# **Intel® 82571EB/82572EI Ethernet Controller**

**Specification Update**

*April 2009  
Revision 6.1  
Order Number 321896-001*

### 25. Auto-Cross Sample Timer (PHY-related Issue).

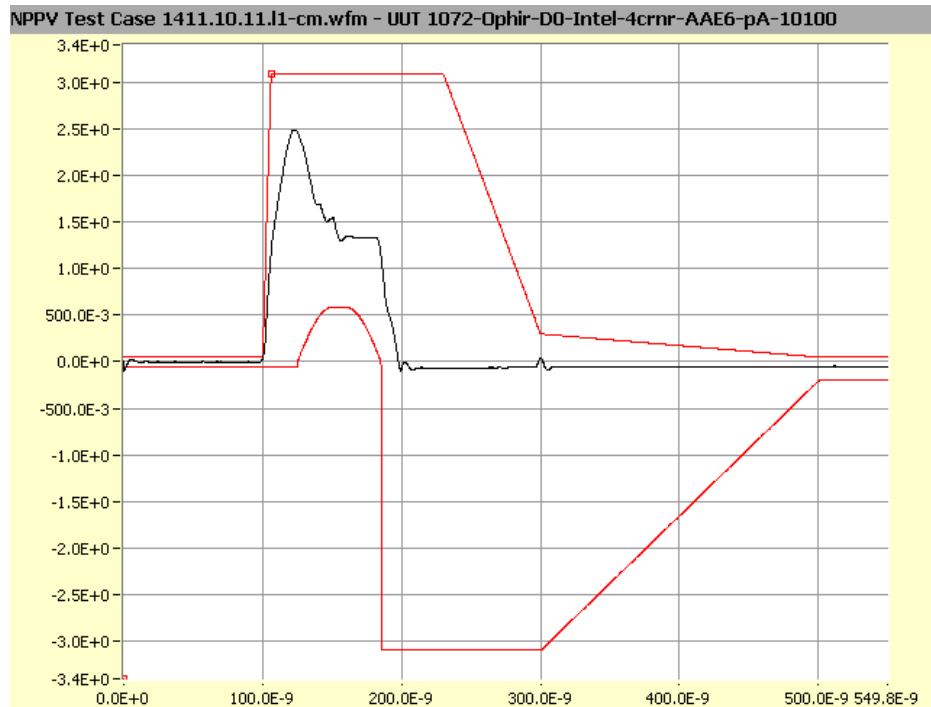
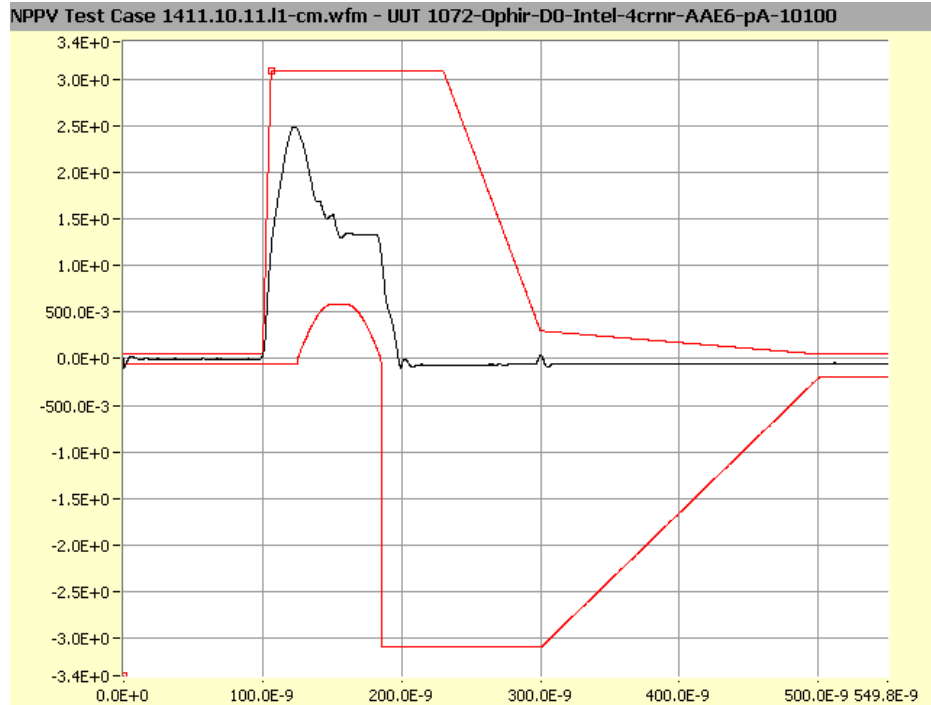
- Problem:** The Auto-Crossover State Machine (Auto-MDIX) has two states: MDI\_MODE and MDI-X\_MODE. The time that should be spent in each mode is defined as an integer multiple of a pseudo-random number and a sample timer, which is defined to be  $62 \pm 2$  ms. The PHY is sometimes waiting for a non-integer multiplication of the  $62 \pm 2$  ms – as defined by the specification.
- Implication:** None
- Workaround:** None
- Status:** No Fix: There are no plans to fix this erratum.

### 3. System-Level EMI Test Can Be Affected by 490MHz Harmonic Seen In 10Base-T Waveform Spectrum.

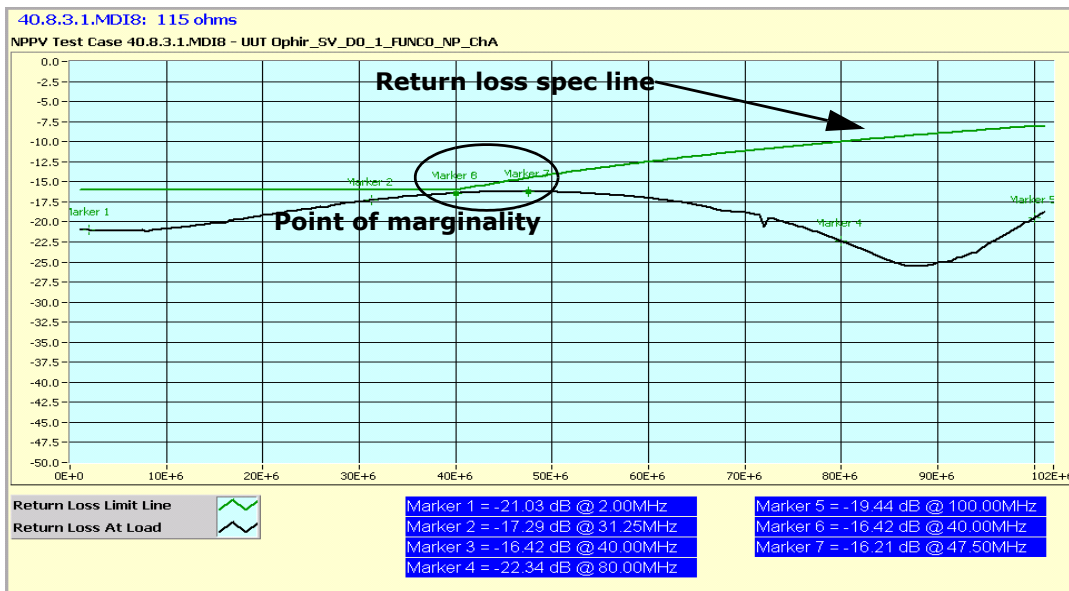
Clarification: This is not a violation of any IEEE specification. This harmonic may, however, contribute to EMI (electro-magnetic interference) in a system-level check at this frequency.

There is no impact on system-level performance.
